<b>Subject:</b> <b>SEAT WARMER TURNS OFF AFTER 10 MINUTES AND DTC B1030:13 IS STORED</b>	<b>Service Alert No.:</b> SA-009/21
	<b>Last Issued:</b> 01/28/2021

This service alert supersedes the previously issued service alert listed below. The changes are noted in Red text.

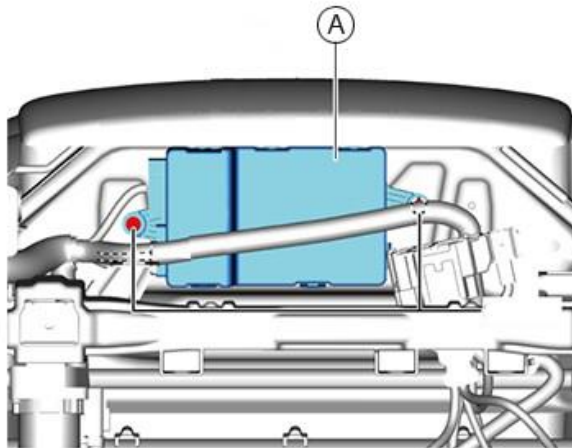
Some customers may complain that the seat warmer turns off after 10 minutes in manual mode and will not turn back on until the vehicle is restarted. DTC B1030:13 (Seat warmer unit (LH) circuit malfunction (heater side)) may also be stored. This may be caused by a faulty seat warmer control unit (A).

1. Verify customer concern.
2. Is DTC B1030:13 stored?
  - Yes - Replace the Seat Warmer Control Unit according to the instructions on MGSS ([SEAT WARMER CONTROL UNIT REMOVAL/INSTALLATION \[\(US\)\]](#))
  - No - This service information does not apply. Go to MGSS for normal diagnosis.
3. Verify repair.

Parts Number	Description	Qty.	Note
BCKA-67-5J0B	Power Unit, Front Seat	1	Part Number suffix "B" or higher
